MONTICELLO RESPONSES TO PREVIOUS PLANT UNIQUE ANALYSIS REPORT CURRENT CONTAINMENT AND PIPING LICENSING ISSUES

TITLE: Monticello Nuclear Generating Plant REPORT NUMBER: NSP-74-105A Plant Unique Analysis Report Volume 5, Appendix A

This appendix provides Monticello plant unique responses to current Mark I containment and piping licensing issues which have evolved as a result of the review of other plant unique analysis reports. It is submitted as part of the PUAR in anticipation of the applicability of these issues to the Monticello plant. The appendix is in a question-and-answer format and addresses topics in each of the five volumes of the report.

SYSTEM ARCHITECTURE

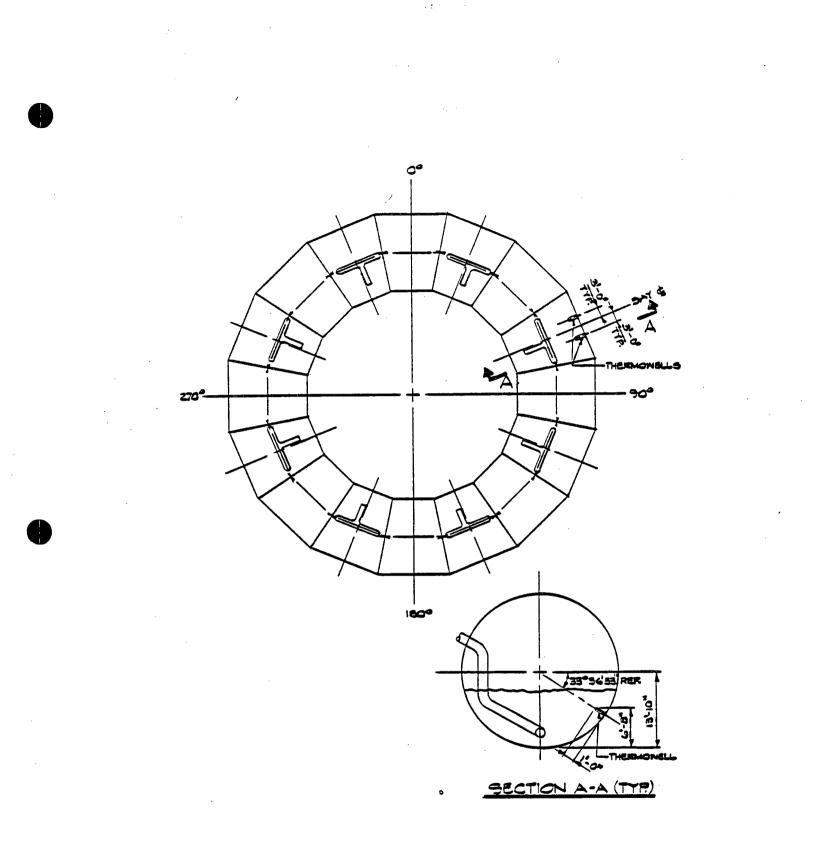
The description of the Suppression Pool Temperature Monitoring System (SPTMS) which is provided in the PUAR is inadequate. Additional information is needed to provide a clear demonstration that the Monticello SPTMS design is in accordance with the requirements of AC Section 2.13.8.3.

The Suppression Pool Temperature Monitoring System (SPTMS) for the Monticello Nuclear Generating Plant is an integral part of the overall post-accident monitoring capability of the plant. The SPTMS consists of two independent and redundant safetyrelated divisions. The safety function of the SPTMS is to provide the plant operator with reliable information on the suppression pool temperature such that the plant can be operated within Technical Specification limits. All components for the system are classified as Class 1E, Seismic Category I, Quality Group B, and the system is designed in accordance with the applicable portions of NUREG-0661 and Regulatory Guide 1.97, Revision 2. All SPTMS safety-related equipment was purchased qualified to the requirements of IEEE Standards 323-1974 and 344-1975. Each division of the SPTMS is physically separated from the other, and either division is capable of providing an accurate measure of the suppression pool bulk temperature.

Figures 1 and 2 show the system configuration and the thermowell/RTD locations.

$\frac{\text{FREE VIBRATION ANALOG DYNAMIC LOAD}}{\text{FACTORS FOR } (k_{\text{B}}/\text{m}_{\text{S}}) \text{ CONSTANT}}$

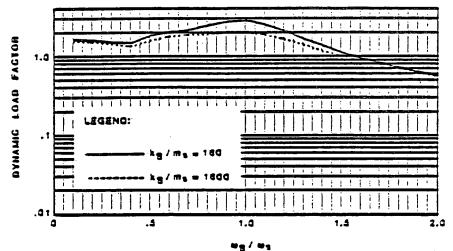
Provide detailed calculations to indicate how the modal correction factors given in Sections 1-4.2.3 and 2-2.4.1 of the PUA report are obtained.

Figure 10.3-3 contains a comparison of DLF's for the cases with  $(k_B/m_s)$  equal to 160 and 1600, assuming a structural frequency of 20 Hz. The maximum DLF for the case with  $(k_B/m_s)$  equal to 160 is 2.8, whereas for  $(k_B/m_s)$  equal to 1600, the maximum DLF is 2.0. It was determined that the DLF's for the case with  $(k_B/m_s)$  equal to a constant are about 20 to 60 percent larger than the DLF's for the case with  $(m_B/m_s)$  equal to a constant.

<u>CODE ALLOWABLE LOAD - MOMENT INTERACTION DIAGRAM</u> EQ 19 (APPENDIX XVII) EVALUATED FOR PRIMARY STRESSES <u>MONTICELLO INSIDE COLUMN</u>

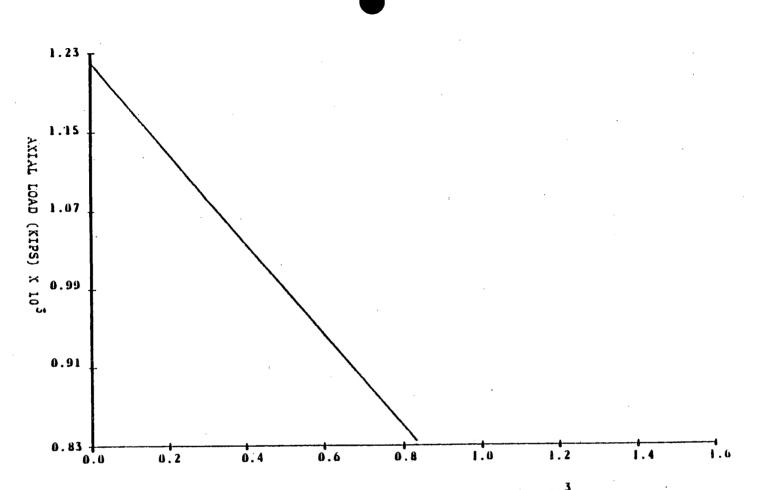
Provide justification for not considering the effect of bending moments in column analysis using interaction formulae.
